Interactive comment on “Development of a meandering channel caused by the plane shape of the river bank” by T. Nagata et al.

Received and published: 7 February 2014

Fig. 1. Migration history of the river channel (Otofuke River, KP17.0-KP21.0)

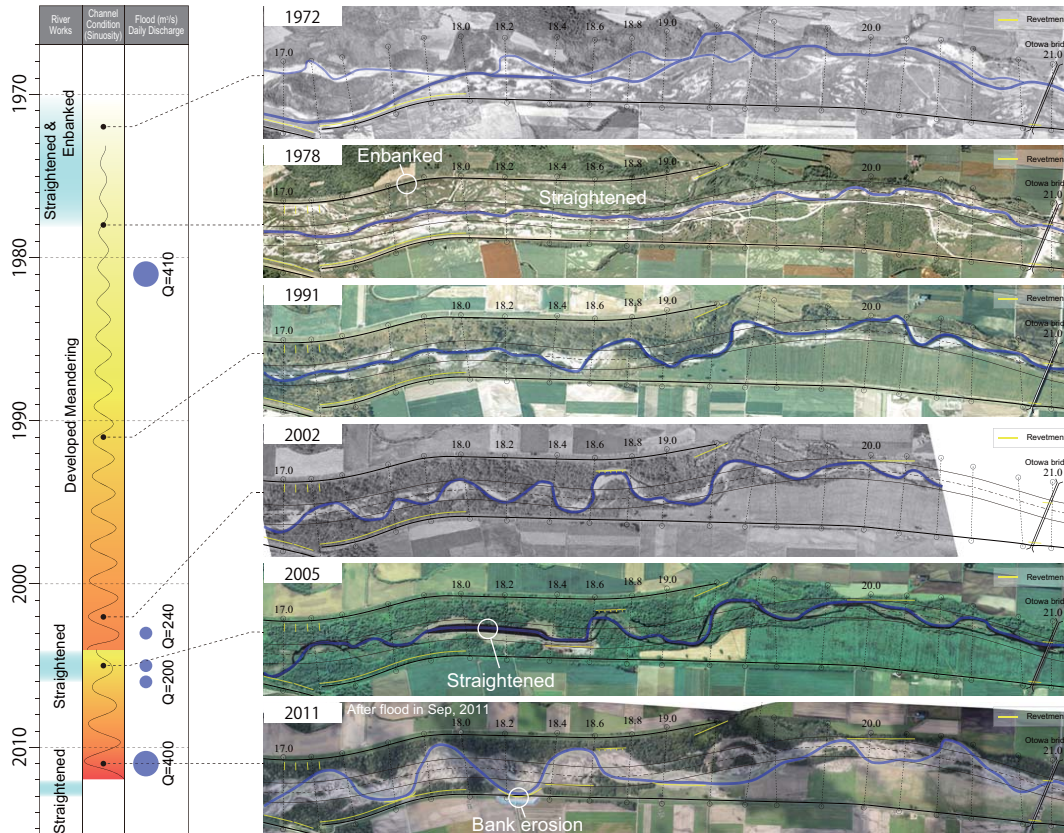
1. In the 1970s, large-scale river improvements were made on almost the entire section that was examined in this study (KP17.0 - 20.0). Aerial photos taken before and after the improvements (1972 - 1978) are shown in the upper part of Fig. 1. In the improvements, a levee was constructed on the right bank immediately downstream of KP19.2, and low-water-channel drilling was done to shift the watercourse toward the center of the river channel. At that time, bank protection was not constructed on the riverbank of the low-water channel. Therefore, the entire river channel became prone to bank erosion. From immediately upstream of KP.19.2, the right bank of the river took the form of a terrace cliff and the watercourse originally ran along the right-bank side. For flood control, the erosion of the terrace cliff was inevitable; therefore, at the river improvement site, the watercourse was allowed to keep running along the right bank side, and as a result, the low-water channel came to have a planar shape with a meander angle of 13° . According to the river channel cross-sections for 1978 (before the 1981 flood), the average width of the low-water channel was approximately 80m and the riverbank

Fig. 2. Cross-section in 1978 and 1984 (Section-1)

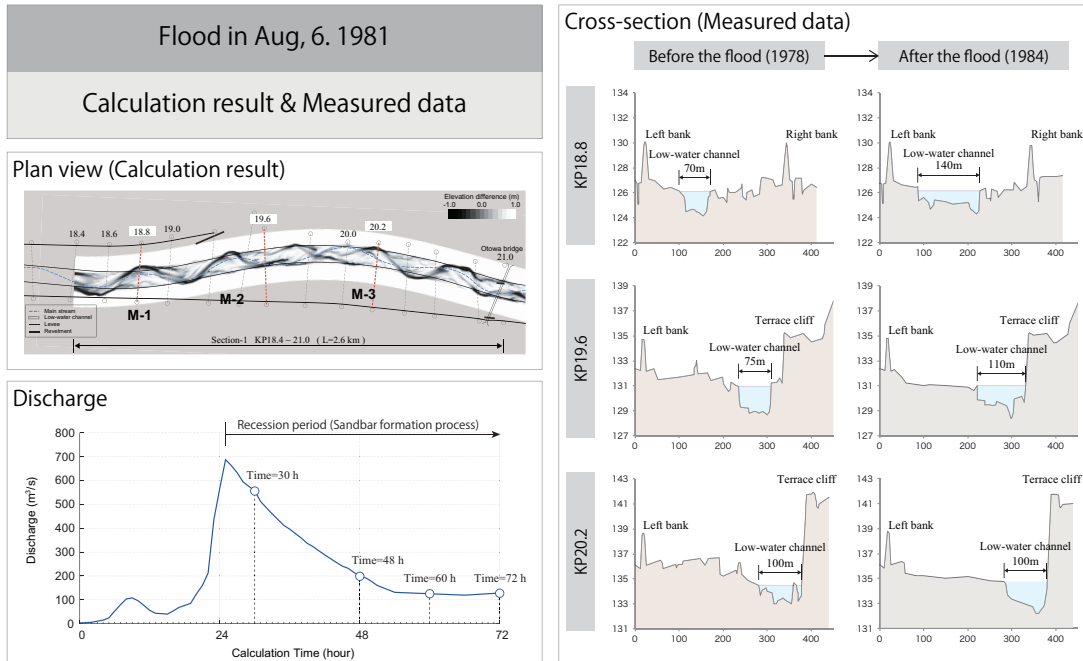
height was approximately 2m, although these varied by location (Fig. 2). However, the aerial photo taken a few years afterward, at the time of the 1981 flood, shows that flood flow with a width of 100m ran through the entire section, and meandering flows that had amplitudes as wide as the river width were produced at M-1, M-2 and M-3 (Fig. 3). This indicates that submerged alternating bars were produced during the flood; accordingly, it was considered that the river width observed during the recession of the 1981 flood (i.e., slightly greater than the width after river improvements; $B = 80\text{--}100$ m) had a dominant effect on river channel formation during the flood. Accordingly, in the analysis for Section-1, the following were given as the initial conditions of the river channel: a curved planar shape with a meander angle of 13° , a 100-m-wide low-water channel and a rectangular cross-section with 2-m riverbank height.

Fig. 4. Calculation results in different calculation condition

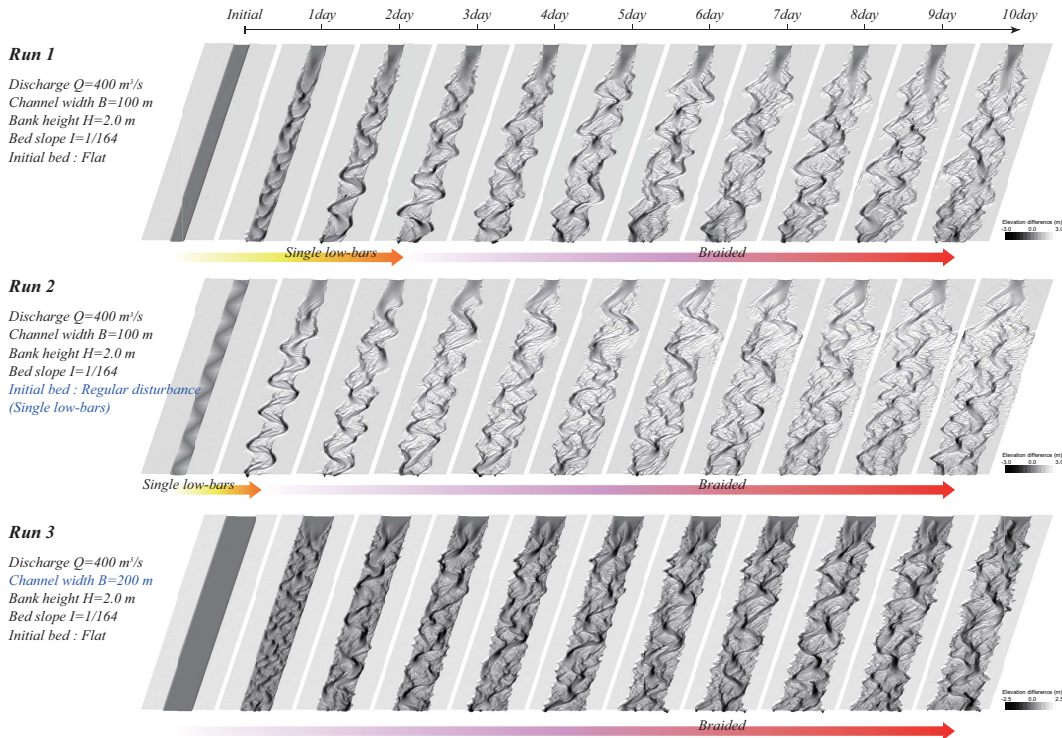
2. As you point out, in this analysis model, braided channels will form if steady flow runs through the channel for a prolonged time. As an example, Fig. 4 shows the results of the analysis in which 400m³/s of steady flow (approximately 2.5 times the maximum yearly discharge of the Otofuke River) ran through the straight channel for ten days. Additionally, in all the simulations in this study, uniform flow depth was given as a boundary condition at the downstream edge of the analysis section and sediment budget at the upstream edge of the analysis section was assumed to maintain a state of equilibrium. As shown in Run 1 in the figure, in the initial stages of water flow (0 - 72h), characteristics of alternate bars temporarily appeared. However, once the meandering had increased beyond a certain degree, new watercourses taking short cuts across the watercourses appeared on the sandbars. After that, the new watercourses repeated irregular watercourse changes while meeting and diverging from the existing watercourses, and with time, braiding streams developed in the channel. Additionally, in Run 2, in which the initial riverbed was given regular disturbance (alternating bars), the development period of alternate bars became even shorter (0 - 48 h), and in Run 3, whose channel width was twice those of Runs 1 and 2, double-row bars developed without the formation of alternate bars, which resulted in the development of braided streams. However, this study was conducted for the purpose of reproducing the phenomena of the development of a single-low meandering channel that occurred in the field and analyzing the dominant factors that led to the phenomena, thus focusing attention on the channel migration that takes place under the specific discharge conditions for the duration of one flood (72 h). In other words, Fig. 4 in the present study, for example, only addresses the development process of alternating bars from 0 to 72 h in Runs 1 and 2. Studying the development process of braided streams that takes place under conditions in which the river width can freely change by means of bank erosion is a very interesting research theme, and it is regarded as a promising avenue of research.

Fig. 5. Schematic diagram of cross-section profile

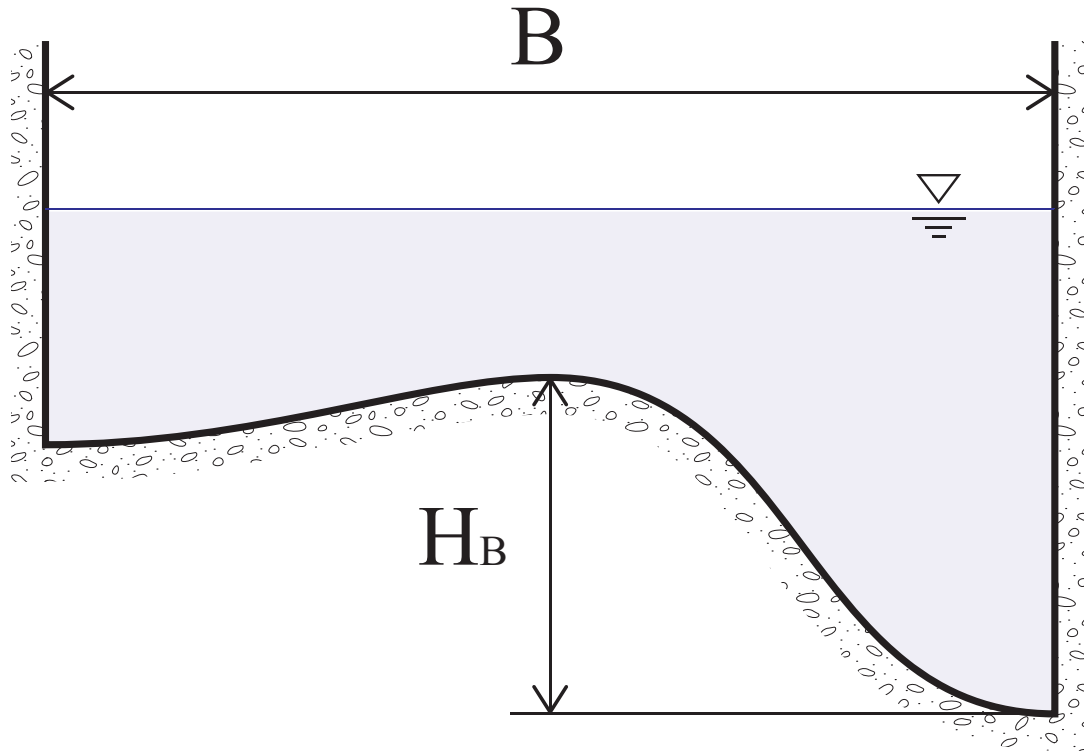
In the development of meandering flow, how the cross-sectional profile of a sandbar changes with time is an extremely important point. Here, the cross-sectional profile of an alternating bar is expressed with wave height HB and river width B , and time series variation of sandbar profile for representative cross-sections of Section-1 and Section-2 are shown in Fig.6. The upper part of the figure shows the following: the results from the experiment on the equilibrium wave height of alternating bars that was conducted using a straight channel and the region where the equilibrium wave height could be found, which was indicated by dimensional analysis (Ikeda, 1983) and onto which the results obtained from this analysis were overwritten. In addition, the lower part of the figure shows the time series variation of the cross slopes (HB / B). The two sections can be said to have the following two points in common. The first is that the sandbar wave height increases with time; however, after the sandbar wave height reaches the equilibrium wave height, the sandbar moves while maintaining the same state. The second is that the time-series variation of the sandbar cross-slope reaches the maximum value when the sandbar wave height reaches equilibrium. Thus, both sections show a convex-shaped variation that has the maximum value as its peak value. This result can be roughly interpreted as follows (Fig. 7). A. Before the wave height has fully develop, the change in the vertical direction predominates (sandbar development process). B. When the sandbar wave height reaches the equilibrium state, the cross-slope also reaches its peak ($HB / B = 0.020 - 0.025$). C. After that, the change in the transverse direction predominates, while the equilibrium height is maintained (bank erosion process). In other words, what the sections have in common is that the planar shape of the meandering flow develops after the cross-sectional profile of sandbars has developed. The largest difference between the two section lies in time at which the sandbar wave height reaches equilibrium (B). It is possible to interpret it as follows. In Section-2, where the sandbar wave height reaches equilibrium at an early stage of the flood, bank erosion continues for a prolonged time, which leads to the development of meandering flows that is more remarkable than that in Section-1. Additionally, the difference in the timing of when the sandbar wave height reaches the equilibrium wave height is brought

Fig. 7. Change of sandbar cross section profile in the flood

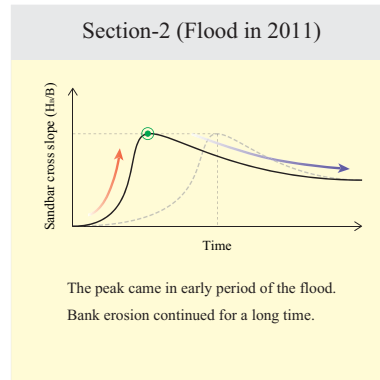
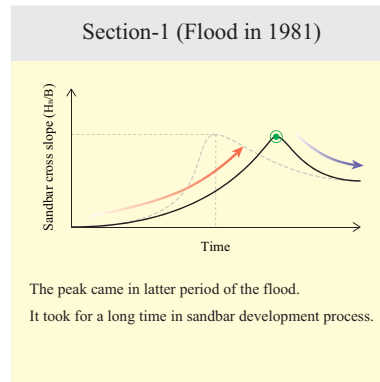
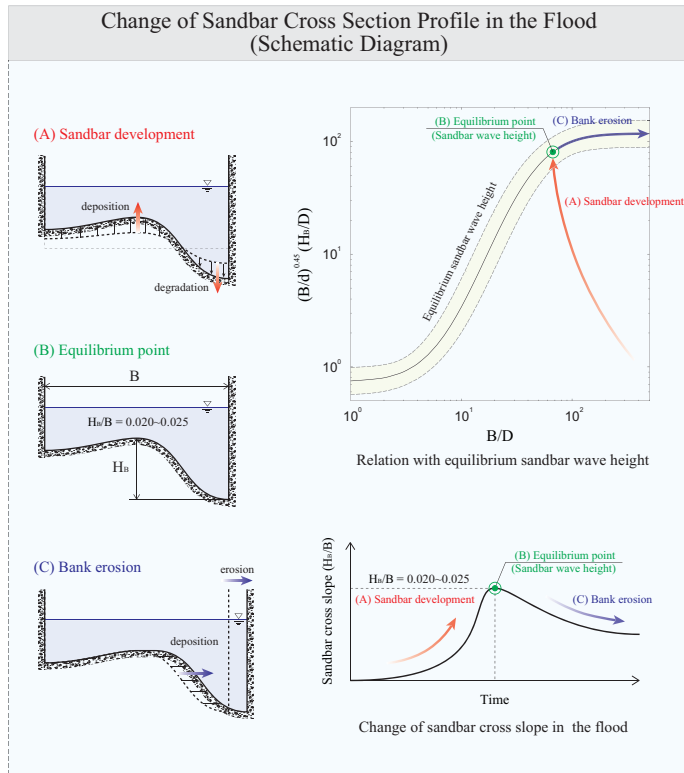
about by the presence or absence of the remaining traces in the watercourse or sandbars that were produced during previous floods. Therefore, different planar shapes of river bank were given to Section-1 and Section-2 as the initial riverbeds for analysis. If a highly developed sandbar like M-1 exists in a low-water channel, it will cause strong meandering flow during a flood. It is assumed that such meandering flow increases the development rate of sandbars to a great degree (peak arrival time of HB/B).
